SUBJECT: **DEMONSTRATION / DELIVERY HOLD - Safety Recall 15S19**
Certain 2015 Model Year Mustang Vehicles Equipped with 2.3L Engines
Fuel Tank, Vapor Line, and Parking Brake Cable Heat Shielding

DEMONSTRATION / DELIVERY HOLD - Safety Recall 15S19
Certain 2015 Model Year Mustang Vehicles Equipped with 2.3L Engines
Fuel Tank, Vapor Line, and Parking Brake Cable Heat Shielding

FIGURE 1

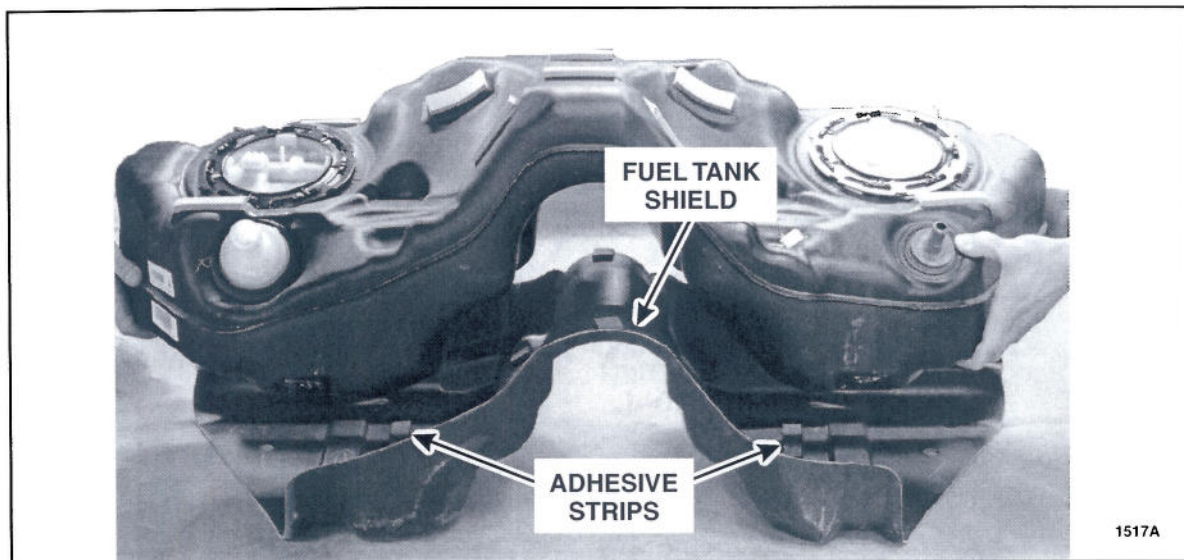
1. Remove the fuel tank. Please follow the Workshop Manual (WSM) procedures in Section 310-01.
2. Remove the fuel tank shield by pulling to release the adhesive strips that secure the shield to the tank. See Figure 1.

FIGURE 2

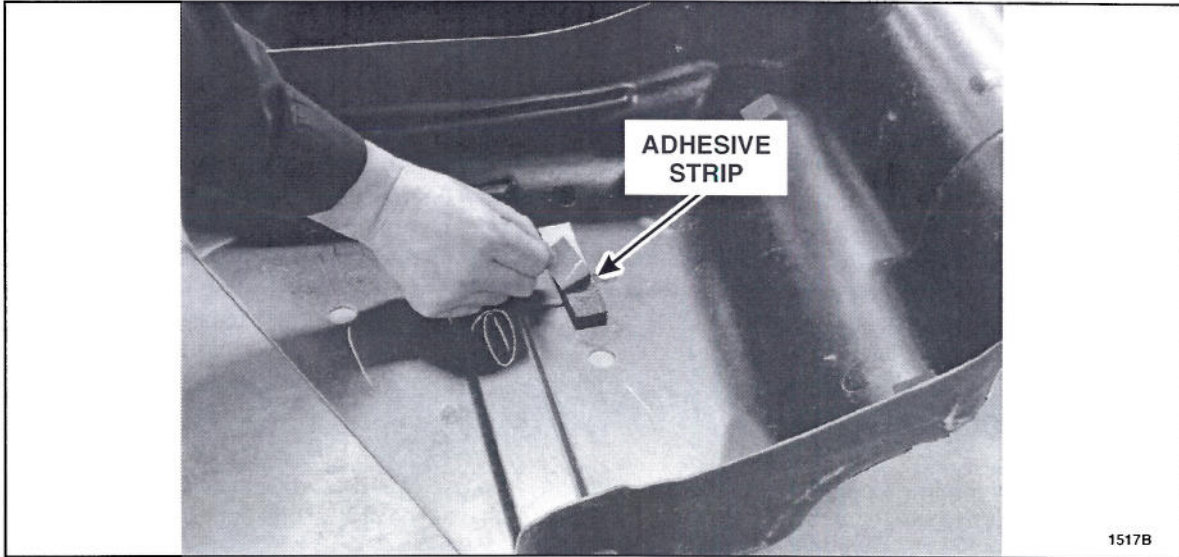
4. Remove the protective film from the *new* fuel tank shield adhesive strips and set the fuel tank into the *new* fuel tank shield. See Figure 2.

FIGURE 4

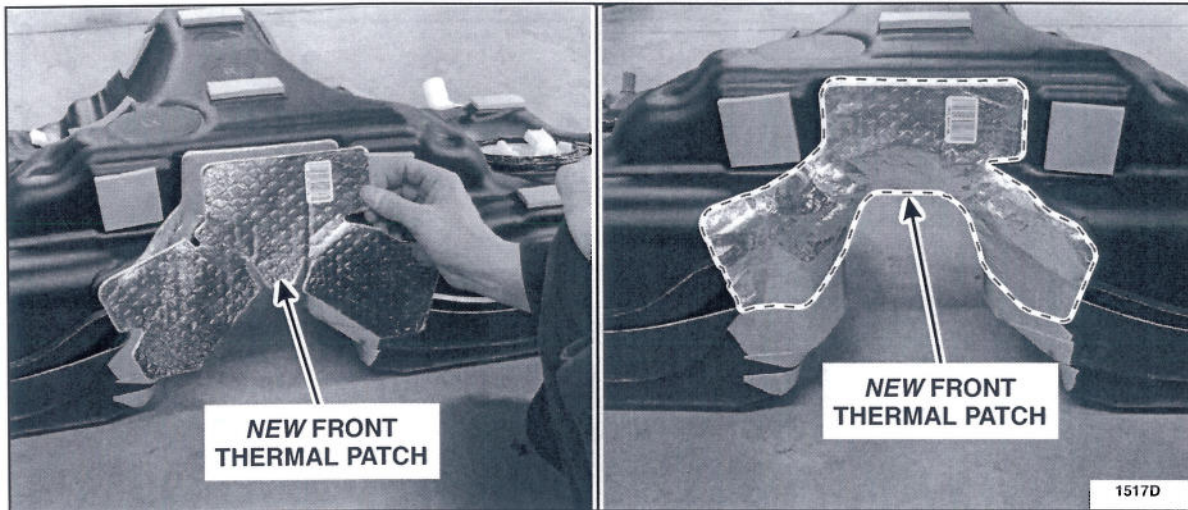
5. Apply *new* thermal patch over the existing thermal patch at the front of the fuel tank. See Figure 4.

FIGURE 5

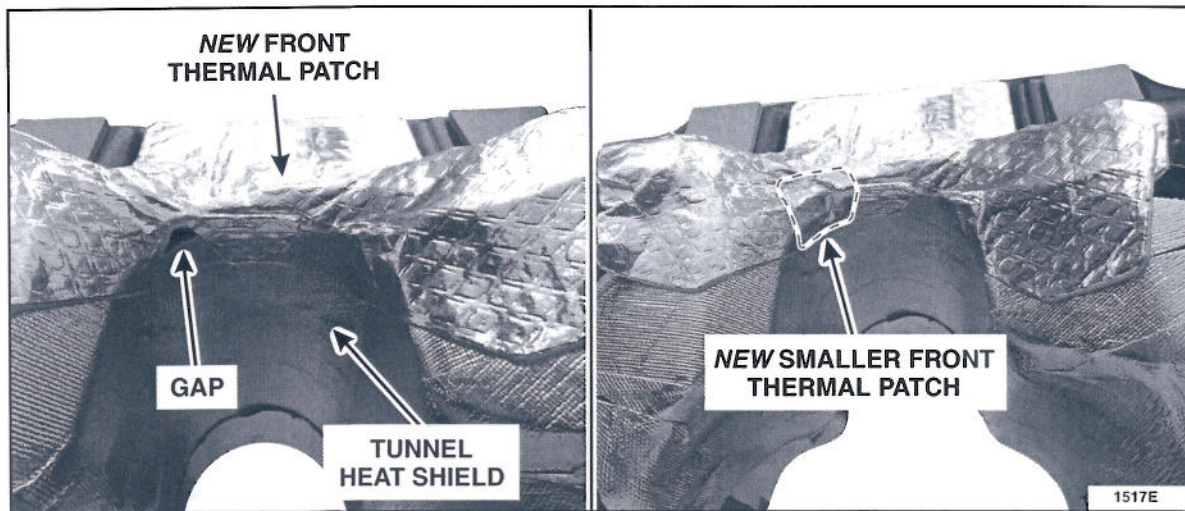
6. Apply the *new* smaller thermal patch over the gap between the tunnel heat shield and *new* front thermal patch. See Figure 5.

FIGURE 6

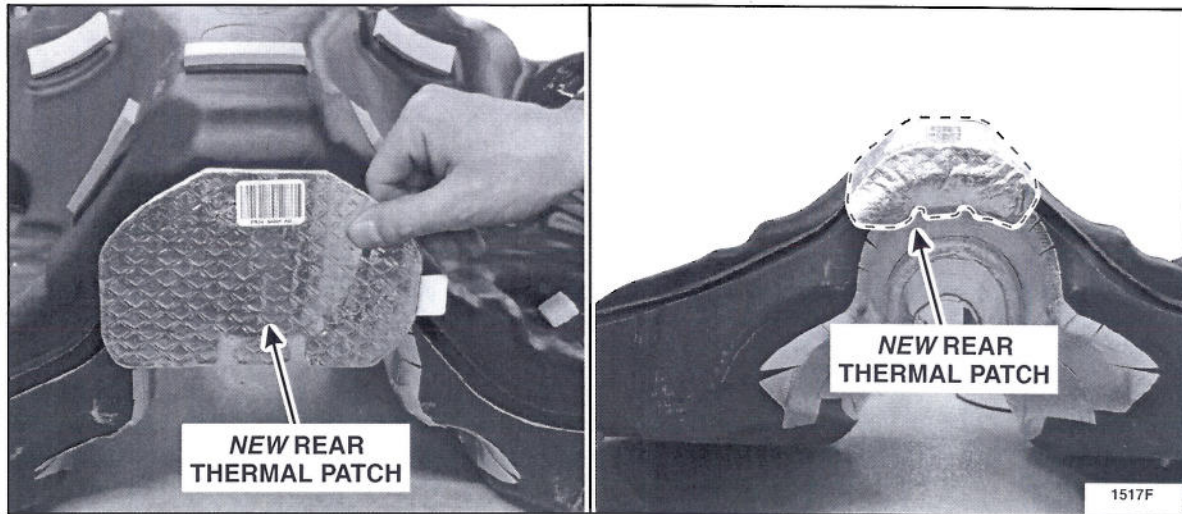
7. Apply *new* thermal patch to the rear of the tank. See Figure 6.

FIGURE 7

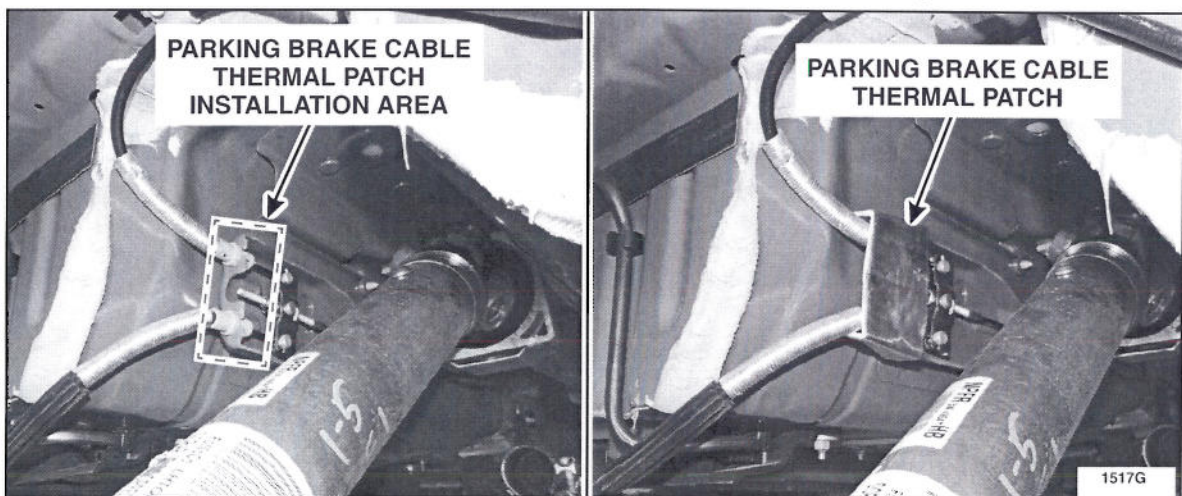
NOTE: Ensure there is no contact between the patch and the moving parts of the cable.

9. Apply *new* thermal patch over the parking brake cable retention collars. See Figure 7.

FIGURE 8

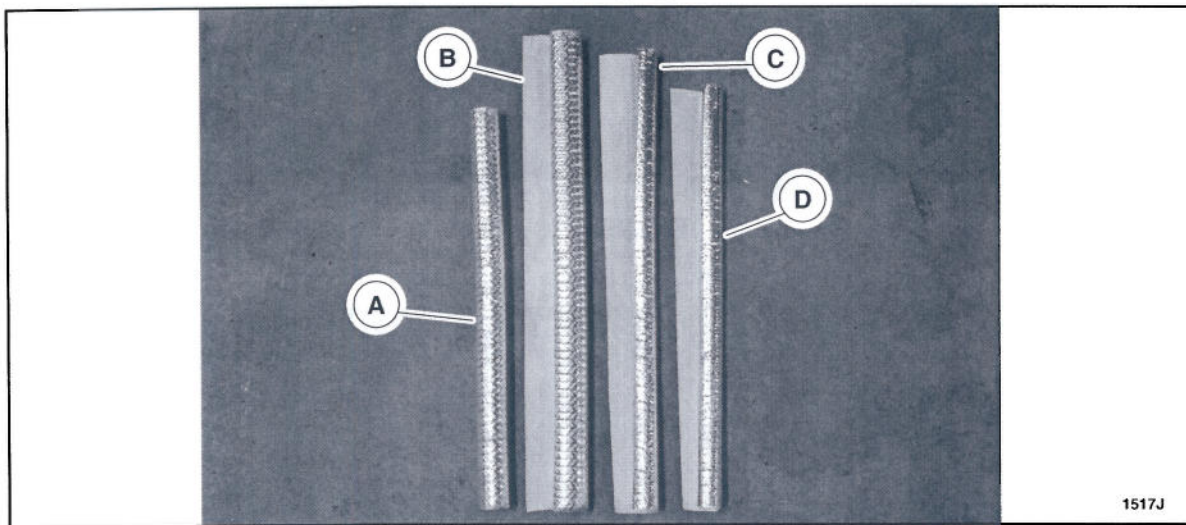
10. Install the thermal wraps onto the vapor lines above the rear sway bar. For steps 10b-10d, gradually slide the thermal wraps over the vapor lines, peeling back the protective film and folding the adhesive flap over to seal the wrap over the vapor line. See Figures 8 through 11.
 - a. Remove the fresh-air hose from the rear subframe and slide the thermal wrap (19mm dia. x 300mm) over the hose. Reinstall the fresh-air hose to the frame rail.
 - b. Install thermal wrap (19mm dia. x 365mm) to canister load line.
 - c. Install thermal wrap (13mm dia. x 350mm) to canister recirculation line.
 - d. Install thermal wrap (13mm dia. x 320mm) to purge line.

FIGURE 11a

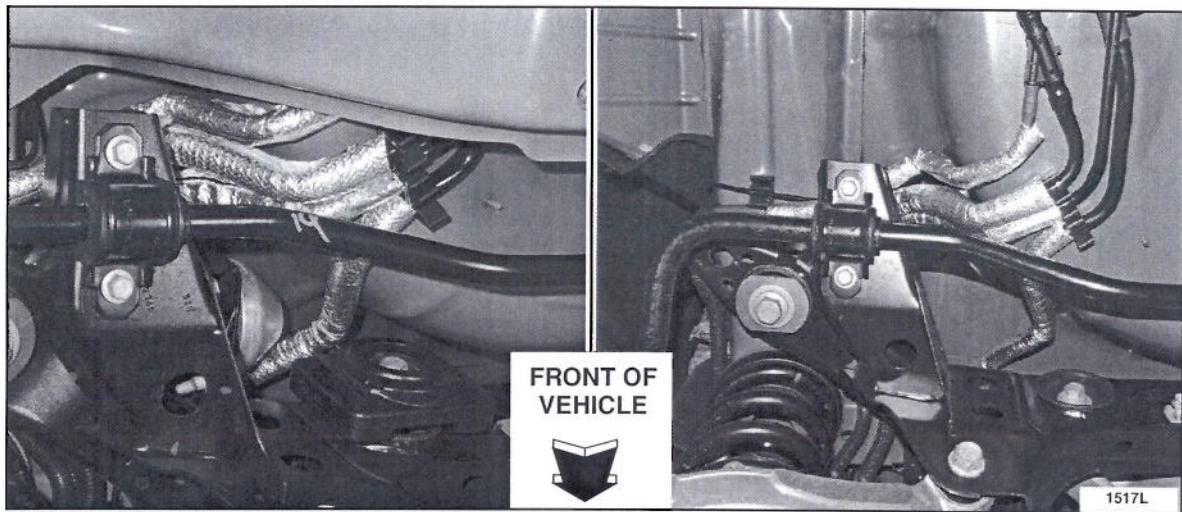
NOTE: See Figure 11a for convertible vehicles, and Figure 11b for coupe vehicles.
